Planning Application No. A/NE-TKL/844
Proposed Temporary Warehouse and Open Storage of Construction
Materials with Ancillary Facilities and Associated Filling of Land for a
Period of 3 Years

Response to the comments of Fire Services Department (FSD)
(as at 7 August, 2026)

1	FS Proposal for Review	Aug. 2026
0	FS Proposal for Review	July 2026
REV.	DESCRIPTION	DATE
PROJECT : Proposed Temporary Warehouse (Excluding Dangerous Goods Godown) with Ancillary Facilities for a Period of 3 years and Associated Filling of Land at Various Lots In D.D. 107, Fung Kat Heung, Kam Tin, Yuen Long, New Territories		
CLIENT :		
FS CONTRACTOR : FAITH WELL ENGINEERING LIMITED		
TITLE : GENERAL NOTES		
DRAWING NO. : FKH2607/FS/01		REV. : AF
DATE : July 2026	SCALE : NA	
CHECKED BY : CAD	DRAWN BY : CAD	
FILE :	DRAWING UNIT : MM

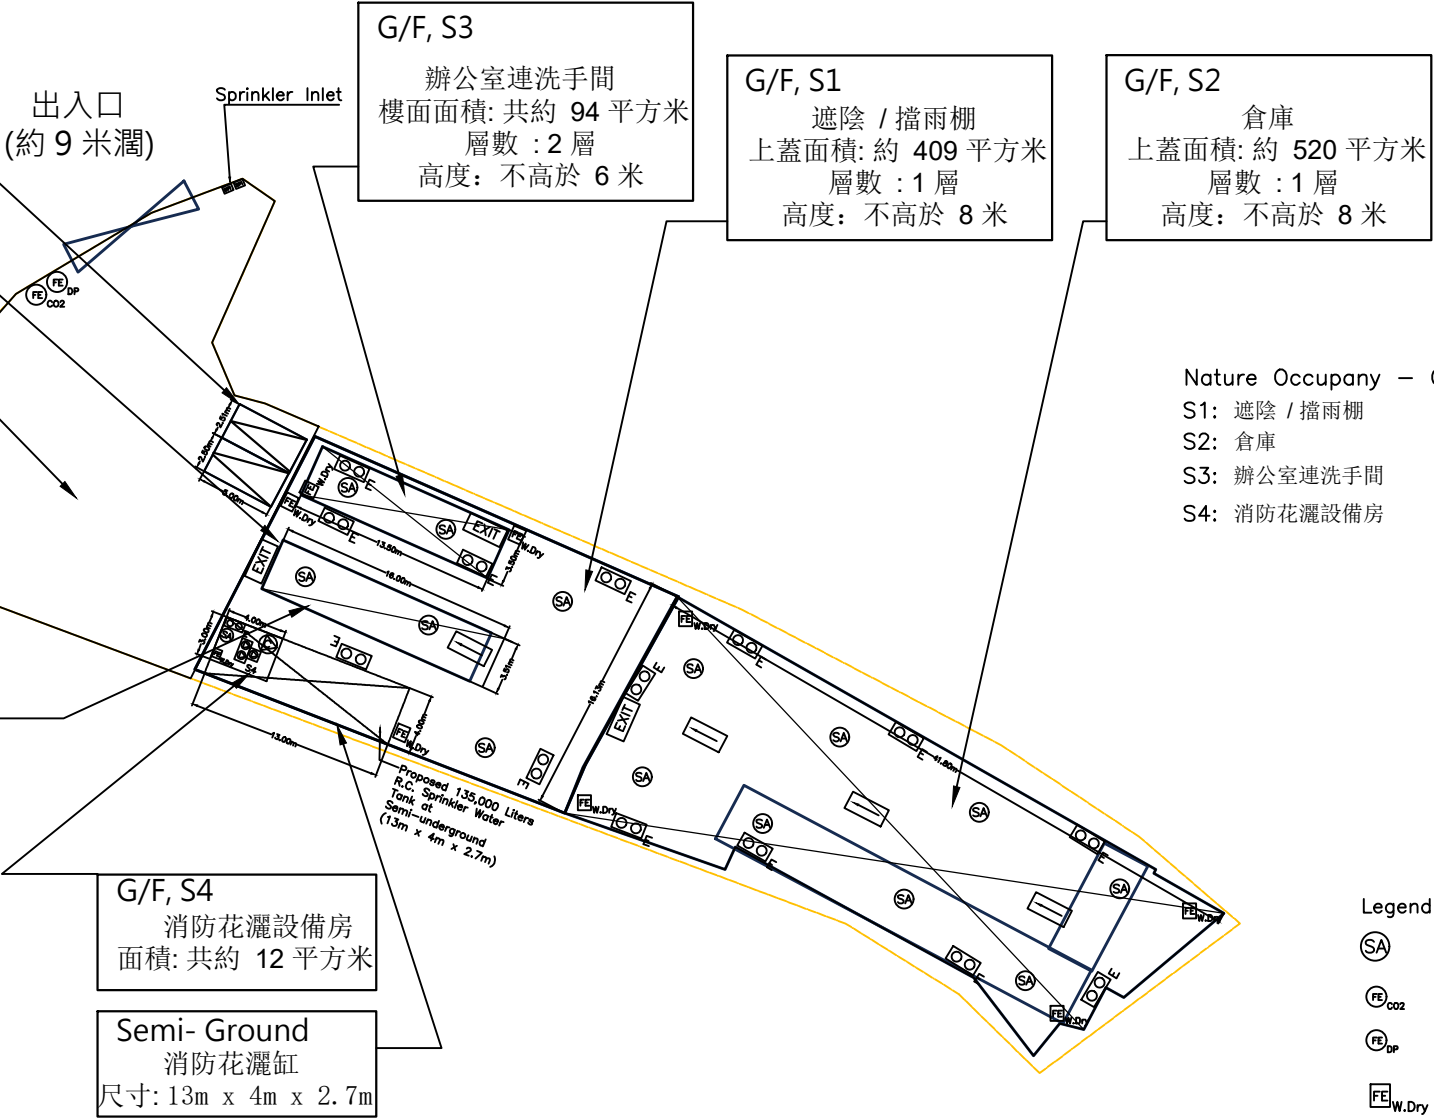
2. For structures with a gross floor area exceeding 230m² (including structure S1), wheeled-type dry chemical fire extinguishers, sprinkler systems, emergency lighting, directional and exit signs and stand-alone fire detectors should be provided for every structure;
消防建議書已更新，請參考附圖。

3. The sprinkler inlet should be provided at prominent location (i.e. at external wall as close as practical to the entrance) and clearly indicated on the plans;
消防建議書已更新，請參考附圖。

5. For every area designated for open storage, a suitable type of portable fire extinguishers should be provided in accordance with the formula: Storage area(m²) x 0.003 and they should be located at prominent positions that are easily accessible for both staff and public within the open storage area.
消防建議書已更新，請參考附圖。

Openable Window Layout of Structure (Side Elvvation) at G/F

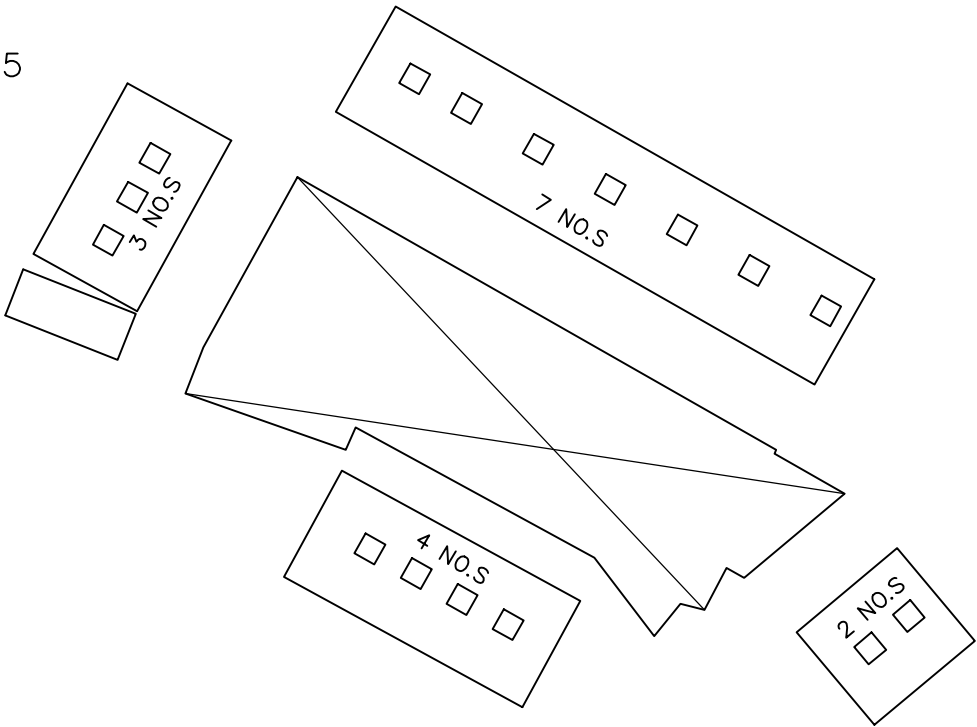
10. Static or Dynamic Smoke Extraction System is not provided. The openable Windows of Structure 1 with Aggregate Area Exceeding 6.25% of the Floor Area as Marked on Plans. (Details see openable window Layout Plan)

6.25% of The Floor Area is $520 \times 6.25\% = 32.5 \text{ sq.m}$

The aggregated area of Openable Window is :
 $1.0 \text{ sq.m} \times (3+7+2+4) \text{ No.s} = 36 \text{ Sq.m}$

$36 \text{ sq.m} > 32.5 \text{ sq.m}$
